AMENDMENT OF SOLICITATION/MODIFICATION OF CONTRACT				1. CONTRACT ID CODE		PAGE 1 OF 11 PAGES	
2. AMENDMENT/MODIFICATION NO. 0002		3. EFFECTIVE DATE 25-Apr-2011		4. REQUISITION/PURCHASE REQ. NO.		5. PROJECT NO. (if applicable)

14. DESCRIPTION OF AMENDMENT/MODIFICATION (Organized by UCF section headings, including solicitation/contract subject matter where feasible) PROJECT NO.: RTCW040501RT RPTC SHINDAND Contract Specialist: Nathan.s.taylor@usace.army.mil SOLICITATION#: W5J9LE-11-R-0040 is hereby modified to incorporate changes stated on Continuation pages. Except as provided herein, all terms and conditions of the document referenced in item 9A or 10A, as heretofore changed, remains unchanged and in full force and effect.							
15A. NAME AND TITLE OF SIGNER (Type or print)				16A. NAME AND TITLE OF CONTRACTING OFFICER (Type or print)			
15B. CONTRACTOR/OFFEROR		15C. DATE SIGNED		16B. UNITED STATES OF AMERICA		16C. DATE SIGNED	
_____ (Signature of person authorized to sign)				_____ (Signature of Contracting Officer)

Questions – RPTC SHINIDAD, HERAT W5J9LE-11-R-0040

Figure 6-20 Anti-Vehicular Ditch Profile with Maximum Incline Slope Not Requiring Stabilization or Berm

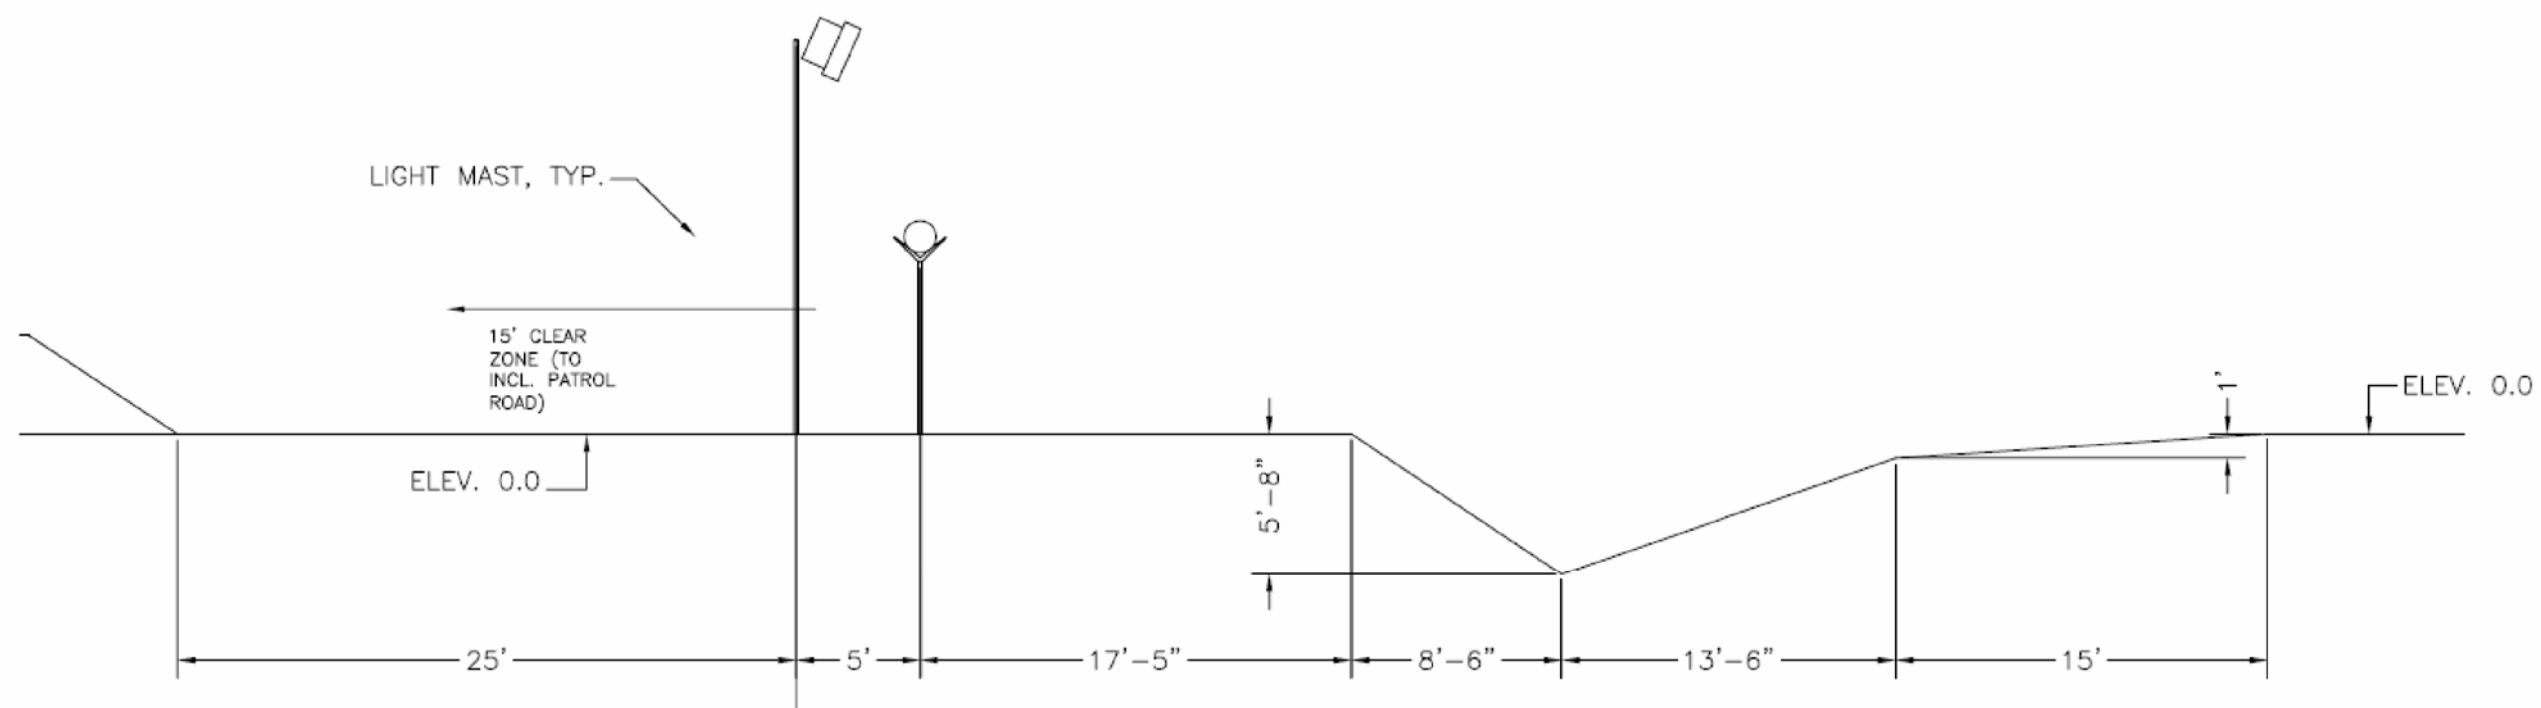
Q26a: Section 01010 Scope of Work, Para 3.0 – states: “Anti-vehicle Ditch (Reference Drawings Provided)”. Please provide referenced drawings.

Q26b: Section 01010 Scope of Work, Para 3.4 “...The standard detail for the anti-vehicle ditch in the Appendix...” – Please provide this standard detail.

A26: See Attached detail for Antivehicle Ditch.

5. The Anti-Vehicle Ditch Diagram UFC 4-022-02, dated 8 June 2009 is hereby incorporated into this solicitation.
